Proposal for amendment to document ECE/TRANS/WP29/GRSG/2010/4 -
Regulation No. 125 (Forward field of vision of drivers)

This document replaces Working Document ECE/TRANS/WP.29/GRSG/2010/4.
The modifications to the text of document ECE/TRANS/WP.29/GRSG/2010/4 are marked
in bold or strikethrough characters.

Figure 1

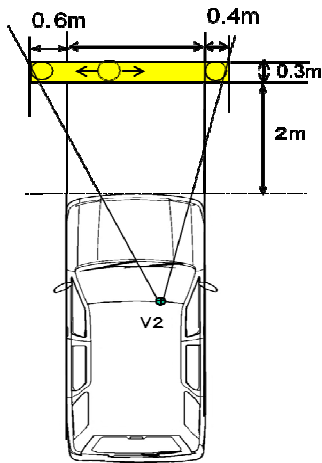
Insert a new paragraph 5.1.4 (including a new figure 1), to read:

“5.1.4. A 1.2 m-tall cylindrical object with a diameter of 0.3 m that is situated inside the space bounded by a vertical plane located 2.0 m in front of the vehicle, a vertical plane located 2.3 m in front of the vehicle, a vertical plane located 0.4 m from the driver's side of the vehicle, and a vertical plane located 0.6 m from the opposite side of the vehicle shall be at least partially visible when viewed directly from V2 (see figure 1), regardless of where the object is within that space, unless it is invisible due to a blind spot(s) created by the A pillars, windscreen wipers, or steering wheel.
